2018-07-24 DP AMENDMENT REVISIONS

The following is a summary of design revisions since the last DP Submission dated May 24, 2018.

IVY ON THE PARK

DP AMENDMENT SUBMISSION

1 PARKING PLAN - LEVEL P1
1/16" = 1'-0"

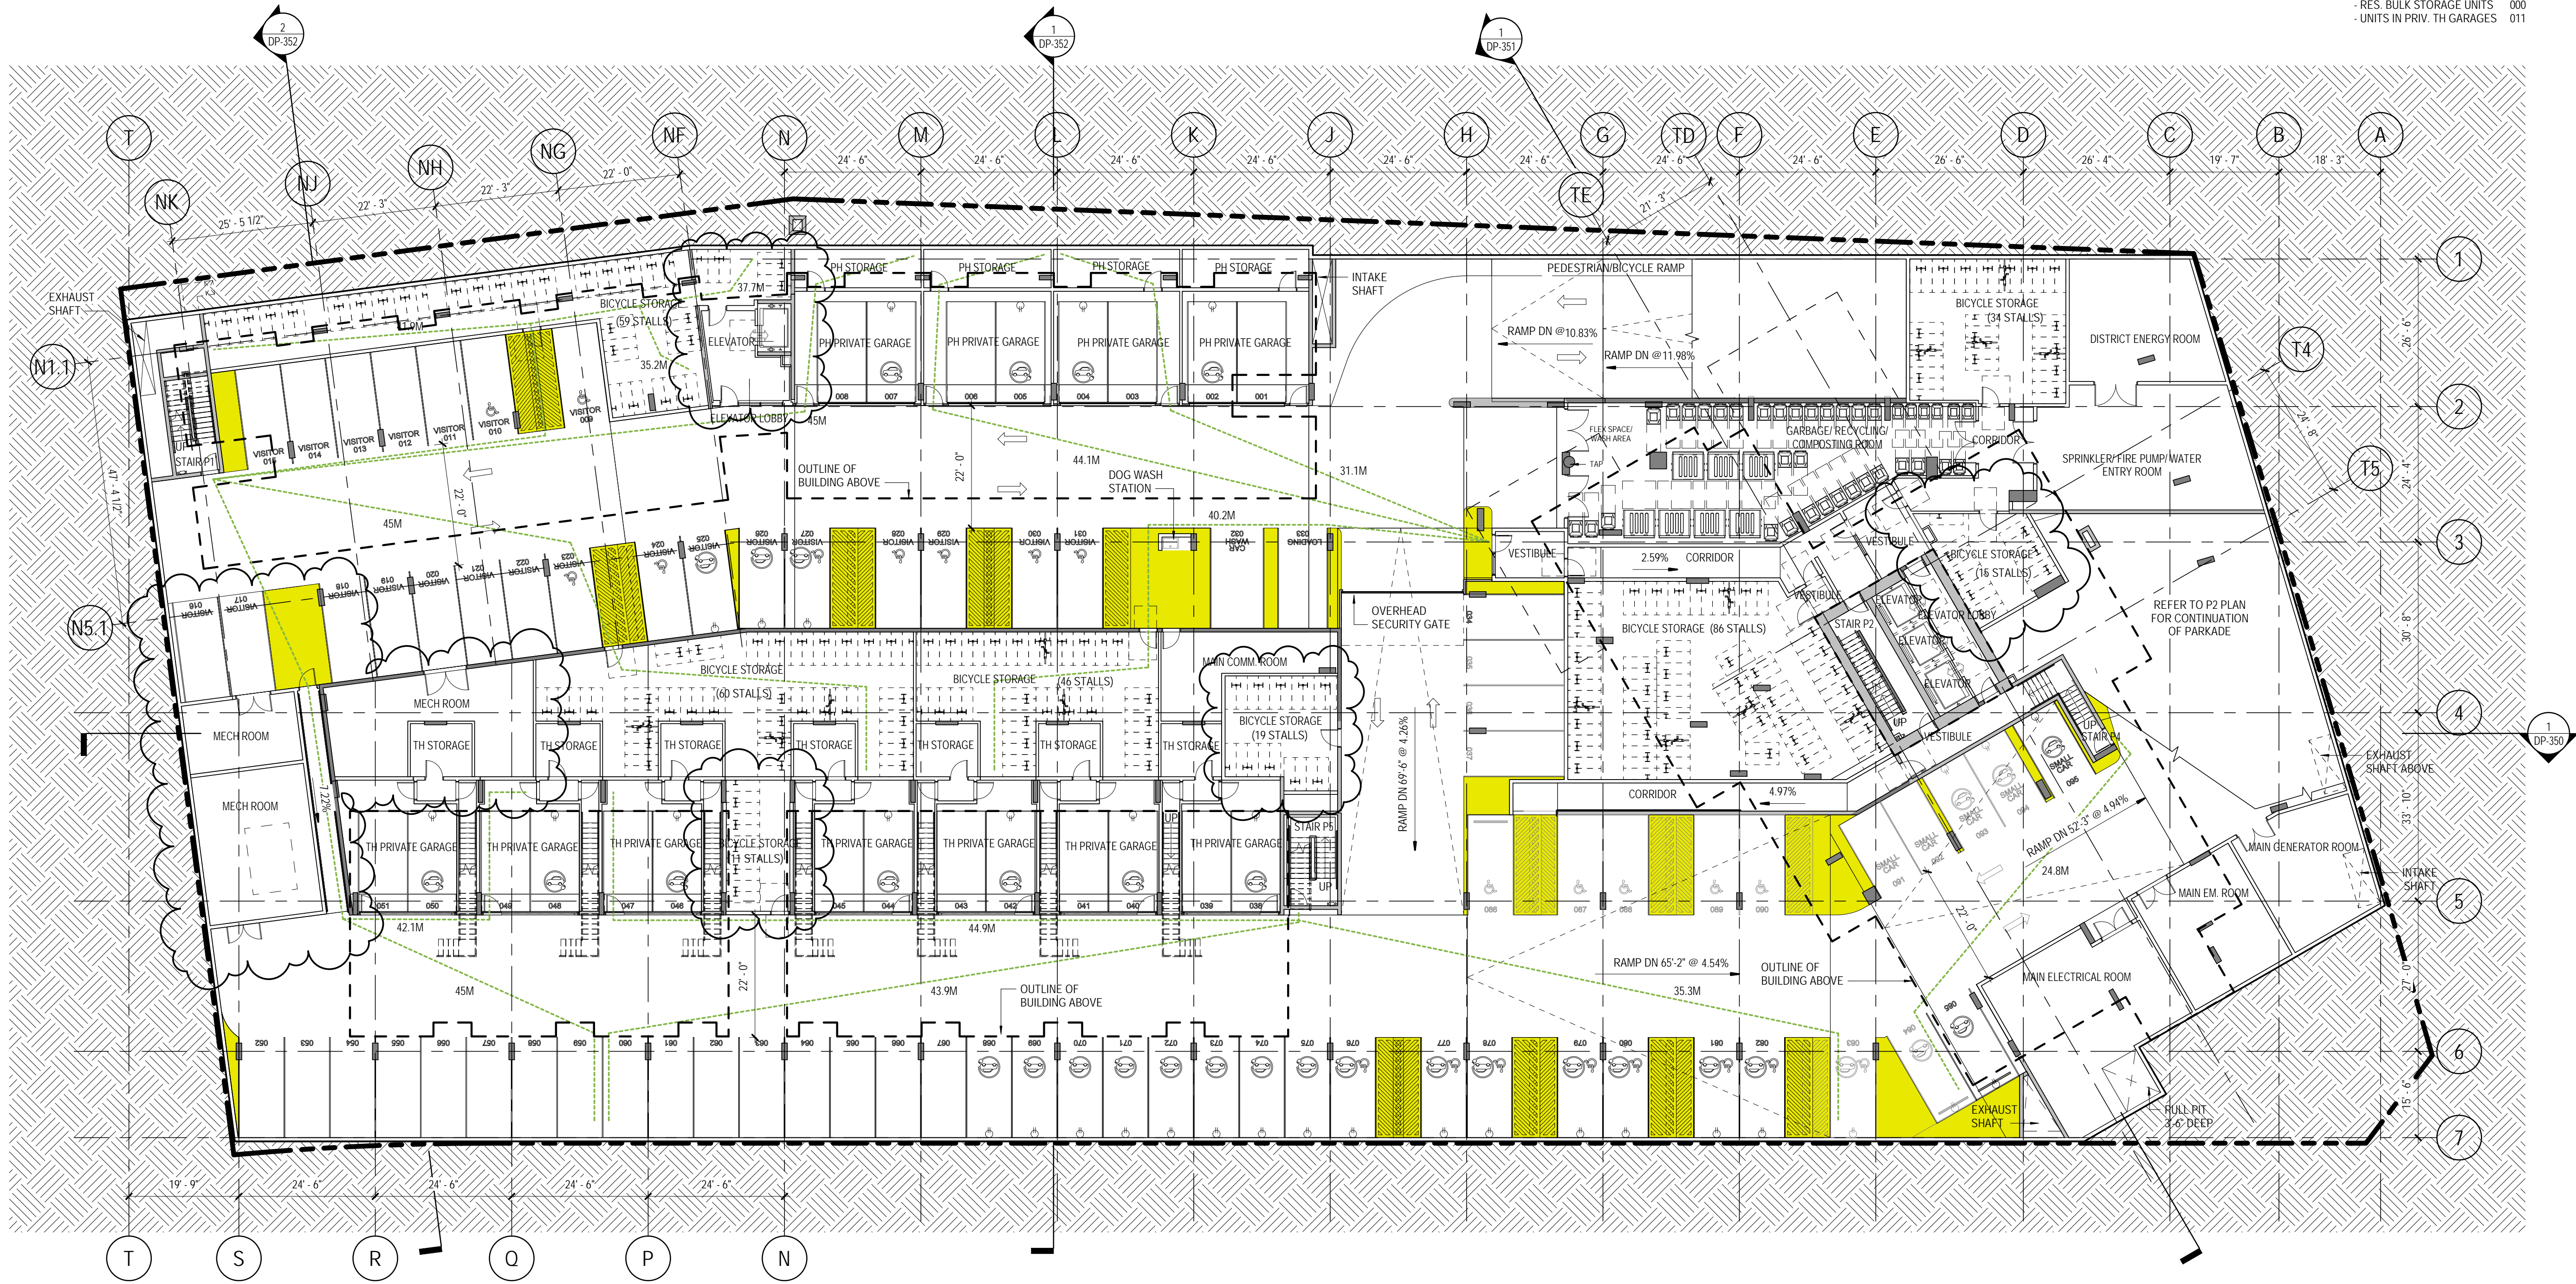
- Level P1 - Mechanical room added to east end of parkade to accommodate cooling tower and other equipment relocated from rooftop of tower.
- Additional bike storage added to meet requirements for additional units.
- Level P2 – Mechanical room added north of midrise building elevator.
- Level P3 – Adjustment to elevator position, elevator machine room and future storage area.
- Site Plan – West site path adjusted to accommodate air intake shaft placement. Air intake shaft for cooling tower added, along with additional planting to screen it from townhouses and pathway. Additional Class II bike parking provided. Air intake shaft added north of midrise elevator lobby, landscape features and planting revised at lobby/entrance.

2 TOWER PLAN - LEVEL 02
1/8" = 1'-0"

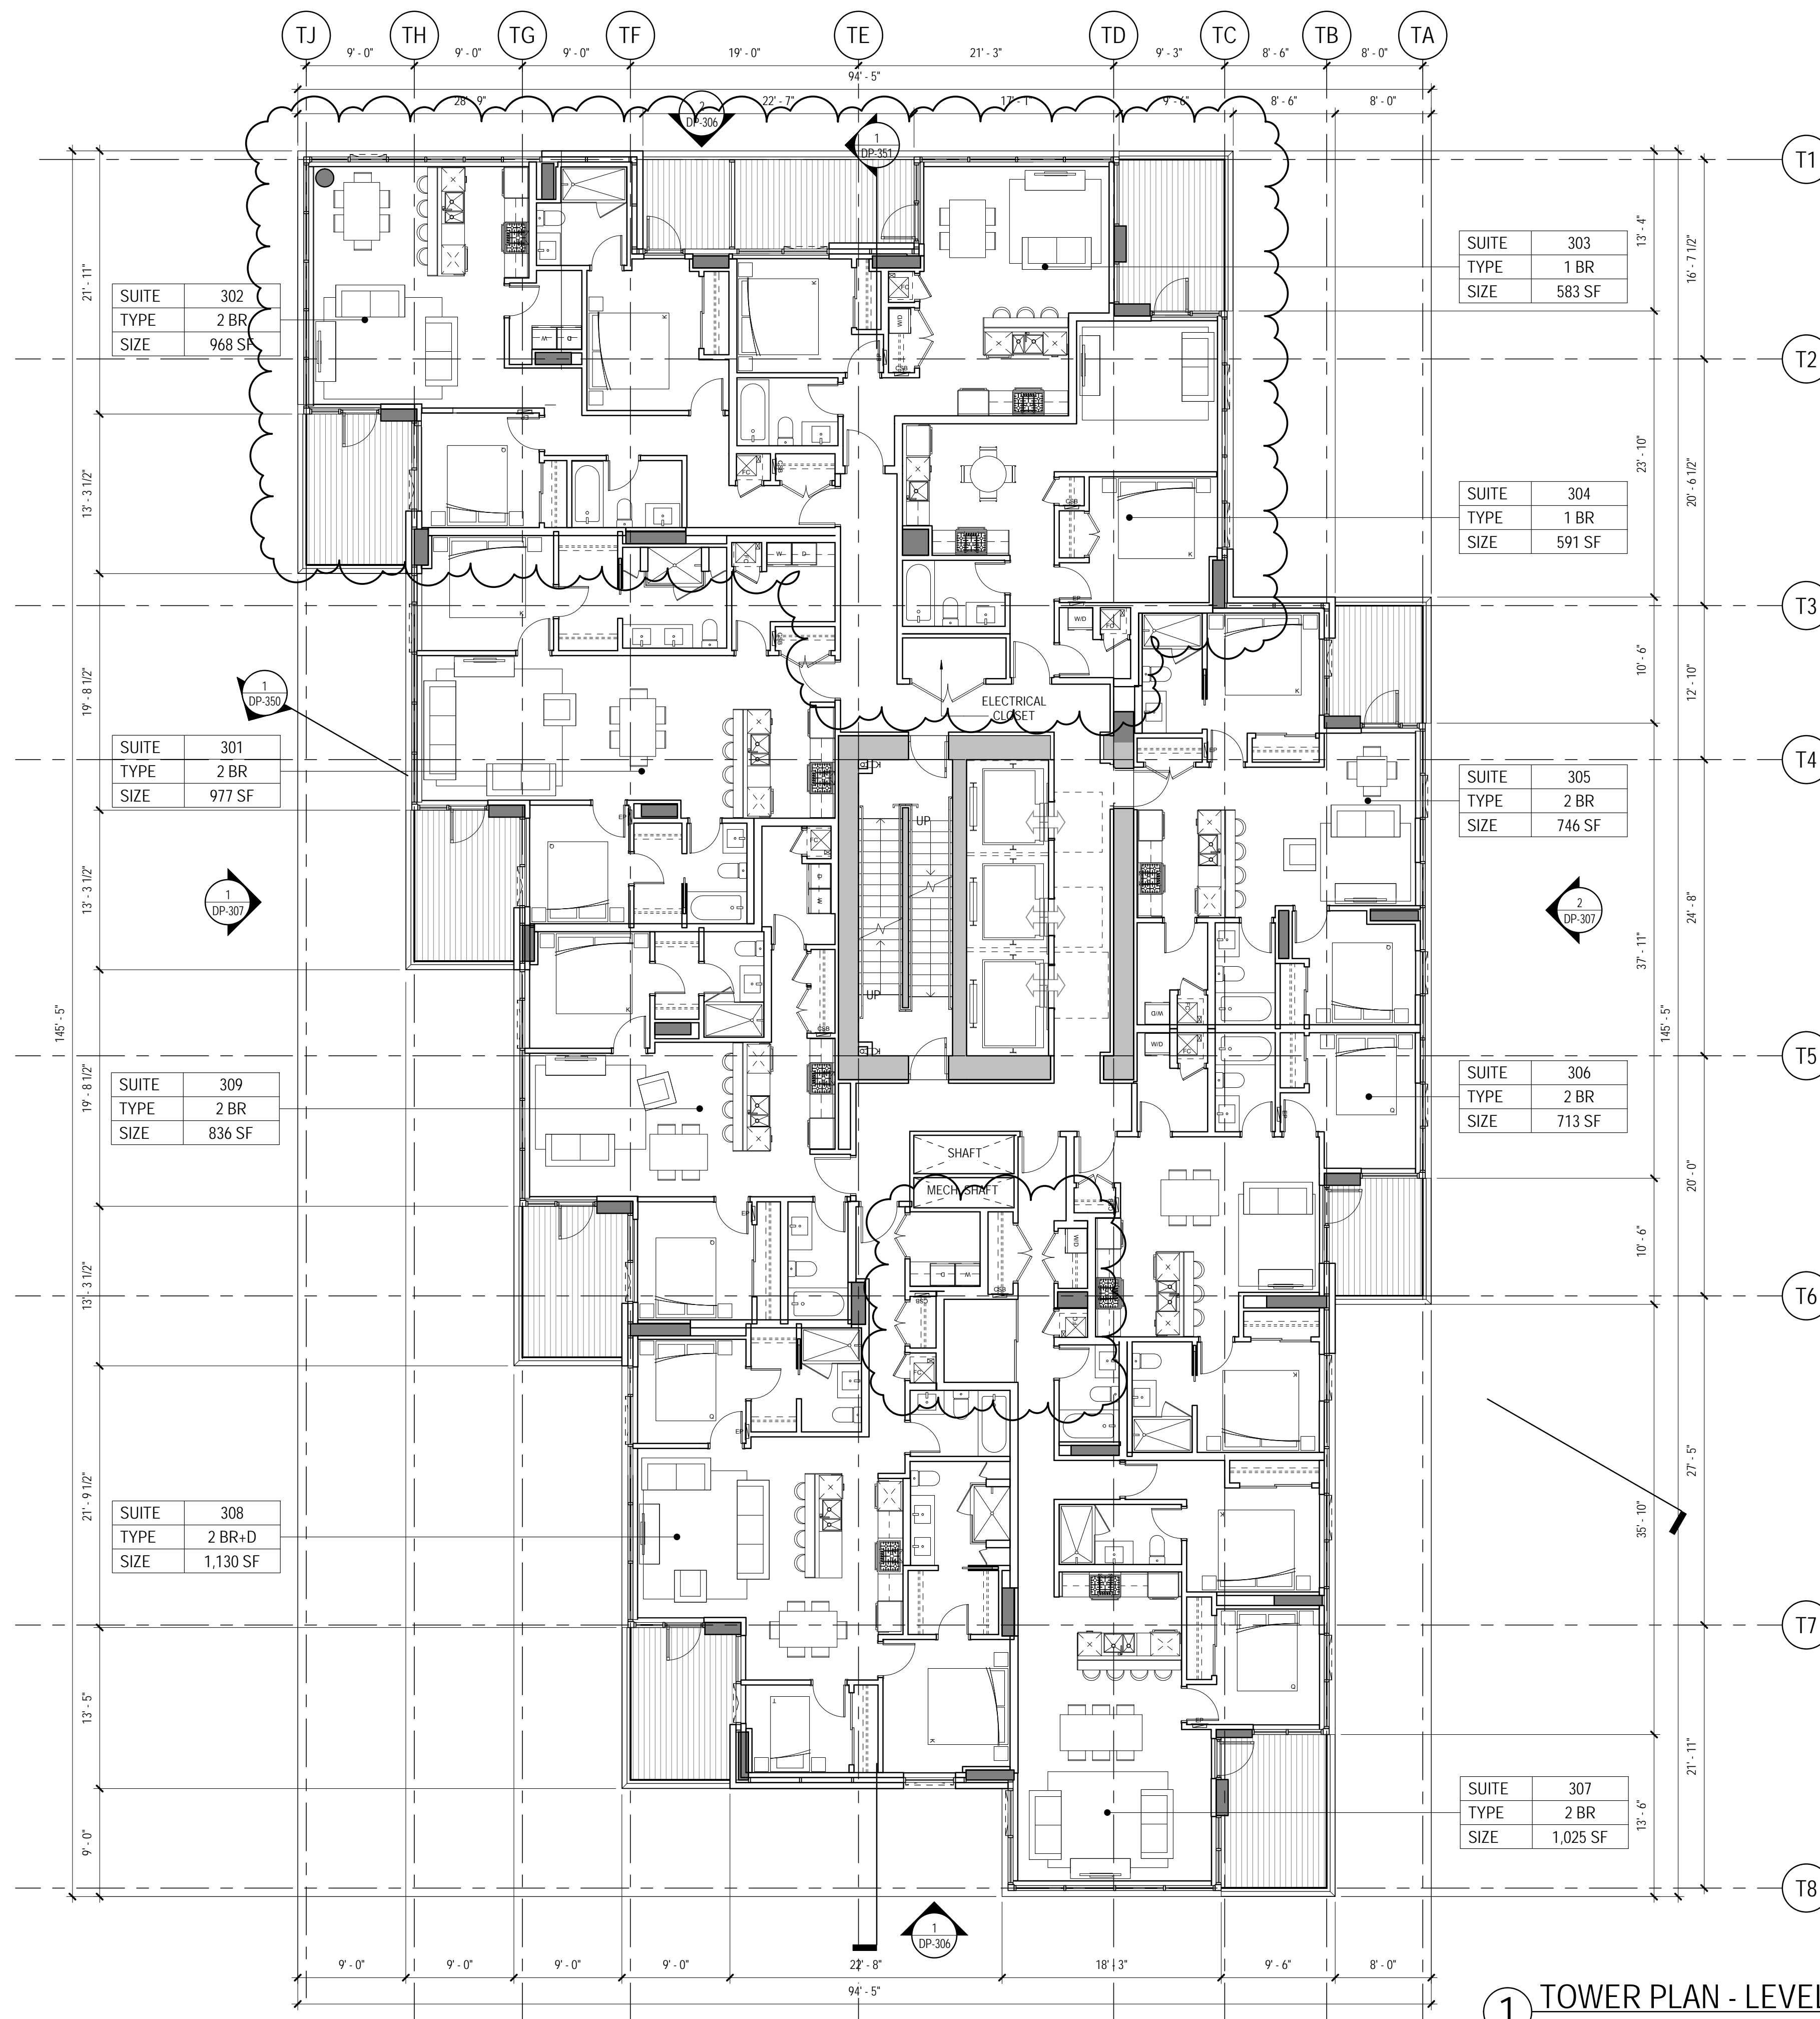
- Typical floorplans have been changed to 3-10 and 11-21, instead of 3-16 and 17-21.
- Tower Level 1 – Building outline near emergency exit revised for clearance
- Tower Level 2 - 2 Bedroom unit at north end of tower replaced with one 1 bedroom unit and a studio suite.
- Tower Levels 3-10 – 3 bedroom unit and 2 bedroom unit at north end of tower replaced with one 2 bedroom unit, and two 1 bedroom units. Balcony added at north end to provide deck access for all units. Minor adjustments to storage space/layouts for units 307 and 308.
- Tower Levels 11-21 – 2 bedroom units (305 & 306) replace the larger 2 bedroom unit that was previously on levels 17-21. Balcony added at north end, minor adjustments to bedroom/washroom layout for unit 1102. Minor adjustments to storage space/layouts for units 1107 & 1106.
- Roof – Cooling tower and the majority of mechanical equipment relocated to P1.
